UNITED STATES PATENT AND TRADEMARK OFFICE

Office Action Summary	Application No. 10/585,919	Applicant(s) NAGATA, TATSUHIKO	
	Examiner MONA M. SANEI	Art Unit 2882

DETAILED ACTION

- 1st modified fig. 4 -

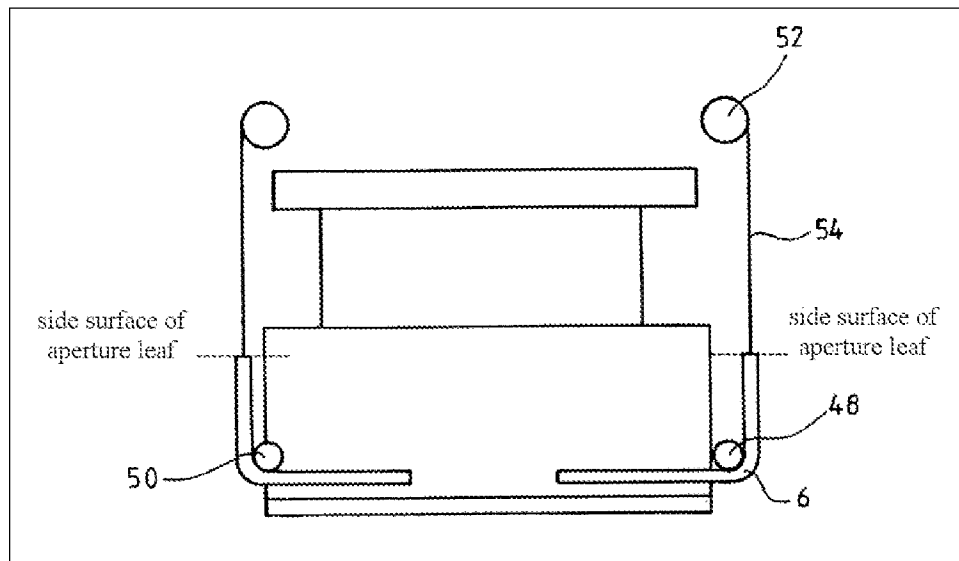
- Regarding claim 8, Saladin et al. teaches that the aperture leaf is rectangular (see figs. 1 and 4; para 0020, first sentence).
- Regarding claim 12, Saladin et al. teaches that the aperture leaves are arranged in the thickness direction (see figs. 2 and 4) so that the aperture leaves freely move through rolling elements (48, 50), and wherein a side surface of each aperture leaf protrudes in the thickness direction to form a holding portion which holds each rolling element (see 1st modified fig. 4 below).

- Regarding claim 13, Saladin et al. teaches that the holding portion forms at least one of a straight line and a curve to hold each rolling element (see fig. 4).

- 2nd modified fig. 4 -

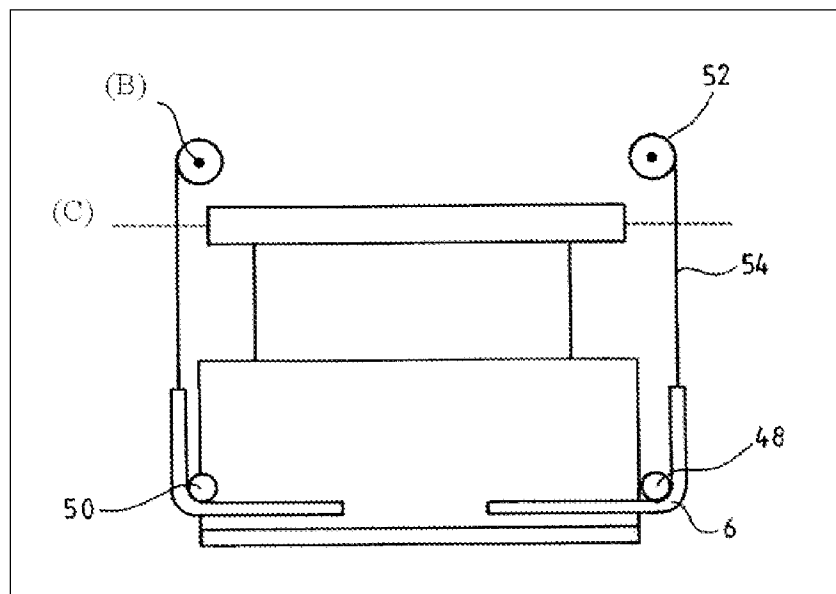
- Regarding claim 19, Saladin et al. teaches that the driver section drives the aperture leaf (para 0019, last sentence; para 0014, lines 6-10) of which the axial direction of the linear member is set to be identical in units of a specific number of the linear members (as shown in the 2nd modified fig. 4 above, the axial direction of the linear member 54 of aperture leaf 6 is

identical to the axial direction of the linear member 54 of aperture leaf 10; and the axial direction of the linear member 54 of aperture leaf 4 is identical to the axial direction of the aperture leaf 8).

- 3rd modified fig. 4 -

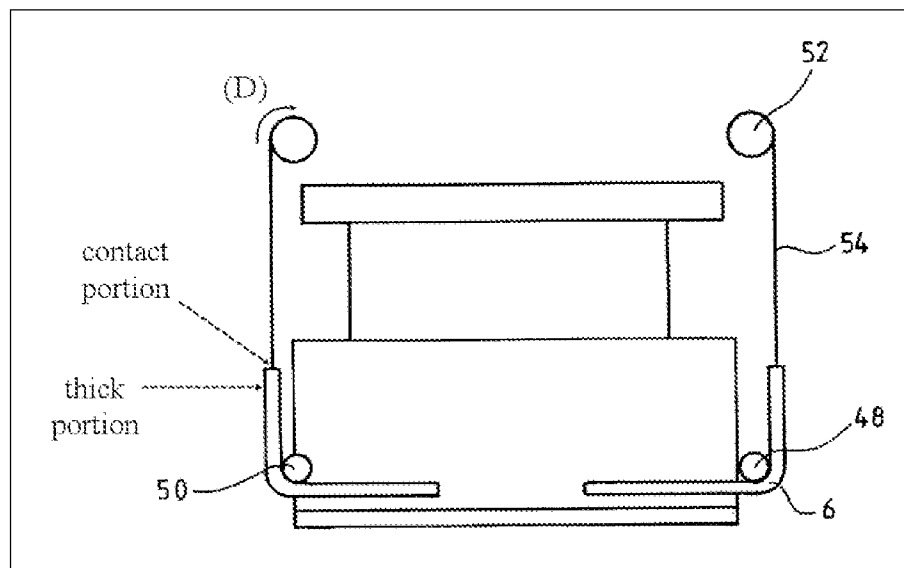
- Regarding claim 22, Saladin et al. teaches that the linear member drives the at least one aperture leaf while contacting the thick portion (fig. 4; para 0019, lines 16-17; see 3rd modified fig. 4 below), is preliminarily bent in a direction (D, 3rd modified fig. 4 below) away from a contact portion between the linear member and the thick portion (see 3rd modified fig. 4 below), and presses a portion (52) in contact with the thick portion (via the linear member 54) so that the linear member is prevented from buckling (the tension created in the linear member as a result of being wound onto the drum 52 prevents buckling of the linear member; para 0019).
